Dockets Nos. 50-277
and 50-278

SUBJECT: TECHNICAL SPECIFICATION AMENDMENTS PERTAINING TO
HEALTH PHYSICS ORGANIZATION CHANGES

SAFETY EVALUATION BY THE OFFICE OF NUCLEAR REACTOR REGULATION SUPPORTING
AMENDMENTS NOS. 94 AND 96 TO FACILITY OPERATING LICENSES NOS. DPR-44 AND DPR-56

PEACH BOTTOM ATOMIC POWER STATION, UNITS NOS. 2 AND 3

Figure 6.2-2

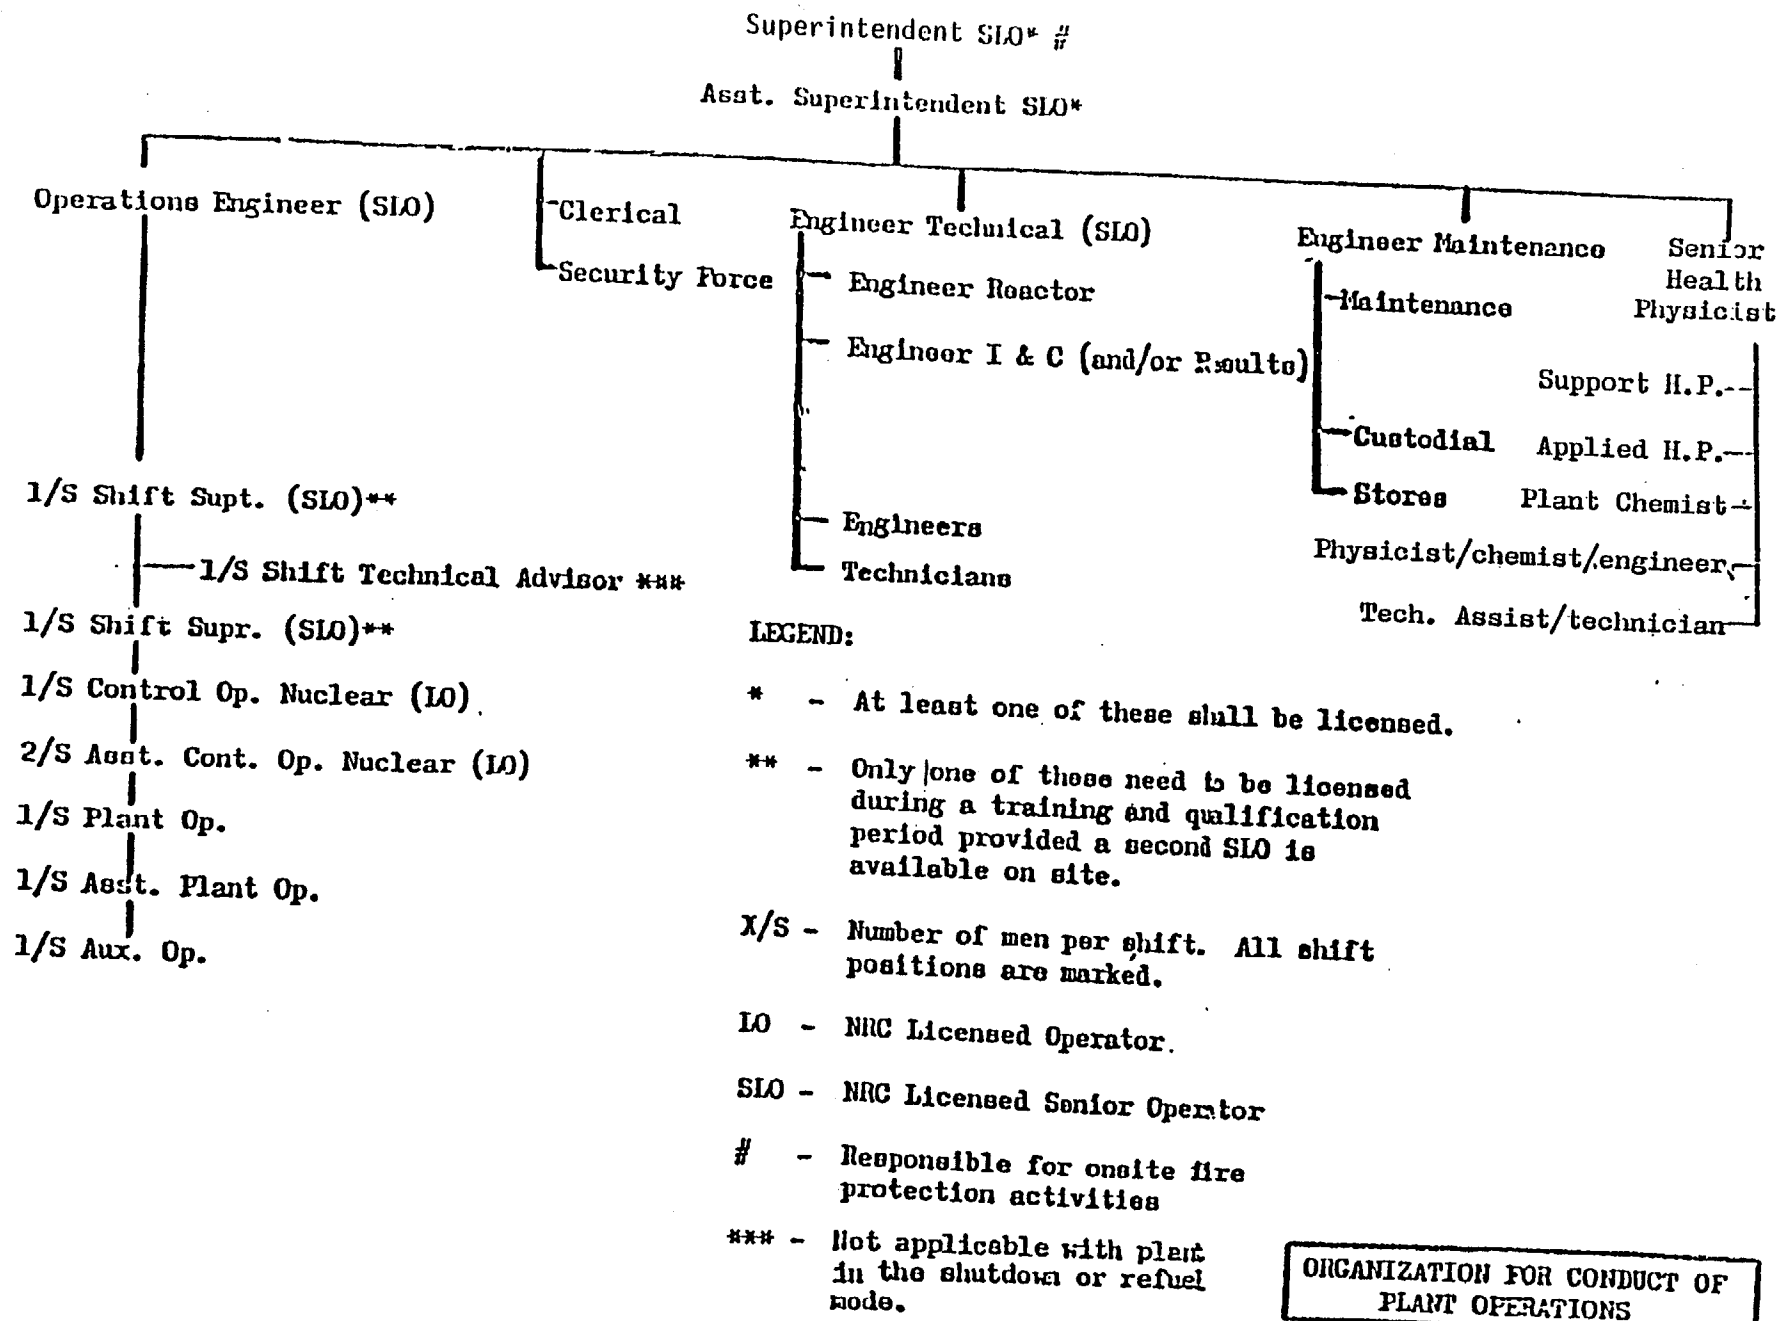
The Philadelphia Electric Company (the licensee) made application by letter dated June 3, 1980, as supplemented by letters dated May 19, 1981, July 7, 1982, and January 28, 1983, to permit changes to Section 6 (Figure 6.2-2) of the Appendix A Technical Specifications (TSs) to reflect changes in the Health Physics organization structure.

The licensee has restructured the Peach Bottom Atomic Power Station Health Physics' organization, Figure 6.2-2, to appoint a new staff position, Senior Health Physicist, who reports directly to the Assistant Superintendent. The Senior Health Physicist will assume the duties and responsibilities of the Radiation Protection Manager (presently described as the Engineer-Health Physics in the Peach Bottom TSs) and will directly supervise the Peach Bottom Station's health physics and chemistry functions. Currently, the Station's Engineer-Health Physics or Radiation Protection Manager reports to the Assistant Superintendent. Thus, the licensee's proposed change will give the Senior Health Physicist a direct channel of communication with upper level Station management and will provide some additional separation from operational pressures. This change meets the recommendations of NUREG-0731, "Criteria for Utility Management and Technical Competence", and Regulatory Guide 8.8, Section C.1.b(3) and, therefore, is acceptable.
